2006 - 2009 Cadillac XLR: Service Bulletin: #PI0299: Harsh Shifts After Replacement of 1-2-3-4 / 3-5-R Clutch Housing

Subject: Harsh Shifts After
Replacement of 1-2-3-4 /
3-5-R Clutch Housing

Models: 2006 - 2009 Cadillac
XLR
2006-2011 Cadillac STS
2007-2011 Cadillac
Escalade Models
2008-2011 Cadillac CTS
2006-2011 Chevrolet
Corvette
2007-2011 Chevrolet
Silverado
2008-2011 Chevrolet
Suburban
2009-2011 Chevrolet
Avalanche, Tahoe
2010-2011 Chevrolet
Camaro, Express
2007-2011 GMC Sierra,
Yukon Denali, Yukon
Denali XL
2008-2011 GMC Yukon
XL
2009-2011 GMC Yukon

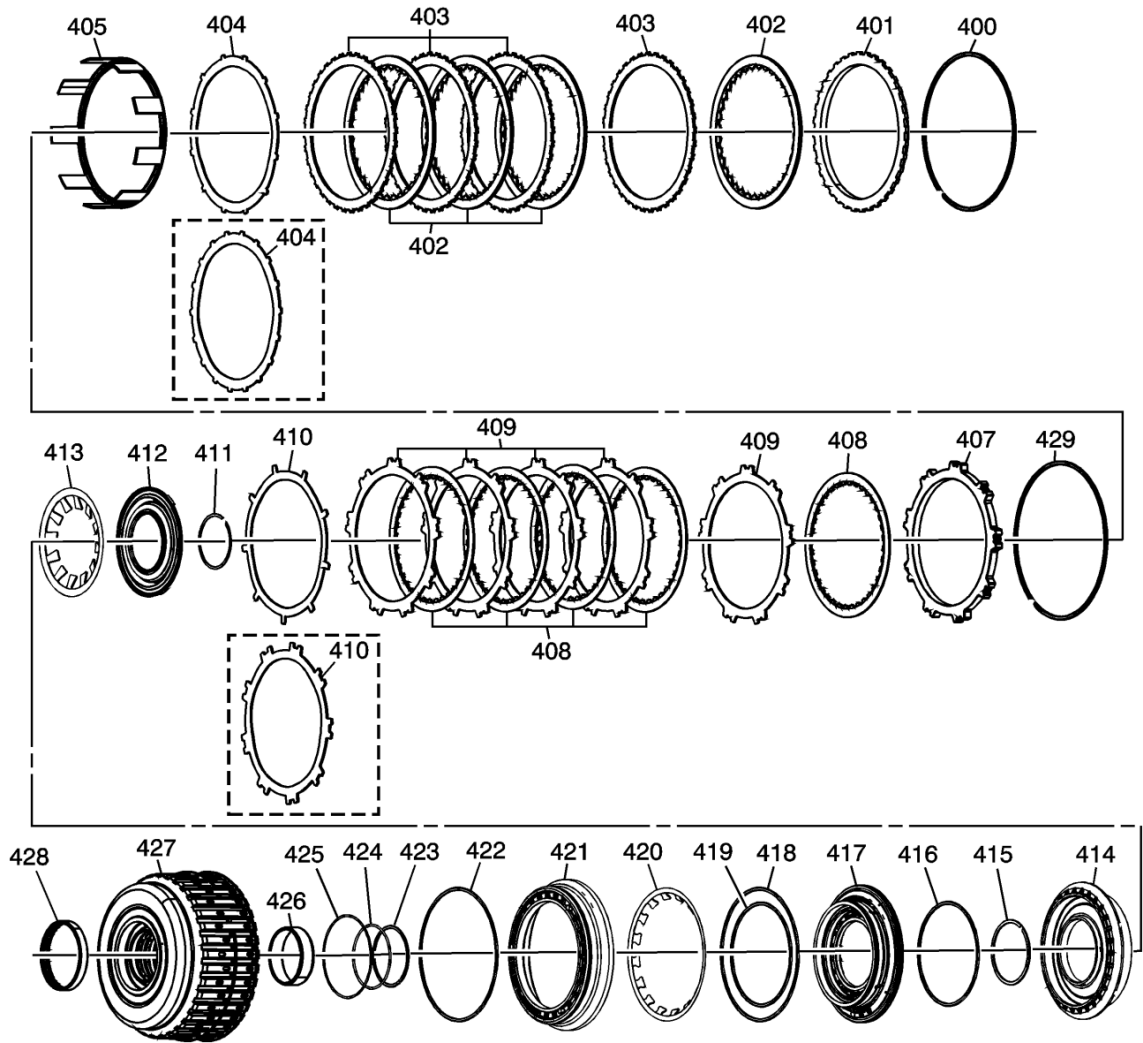
Some customers may comment on harsh shifts after replacement of the 1-2-3-4 / 3-5-R clutch housing (427).

This condition may be caused if the 1-2-3-4 / 3-5-R bearing (428) is not installed into the housing (427). The 1-2-3-4 / 3-5-R clutch housing is currently serviced through parts without this bearing installed and failure to order and install this bearing may result in harsh shifts. Plans are being implemented to service this housing as a kit that will include the bearing.

Note: The parts catalog calls out to order the bearing when the housing is also replaced.
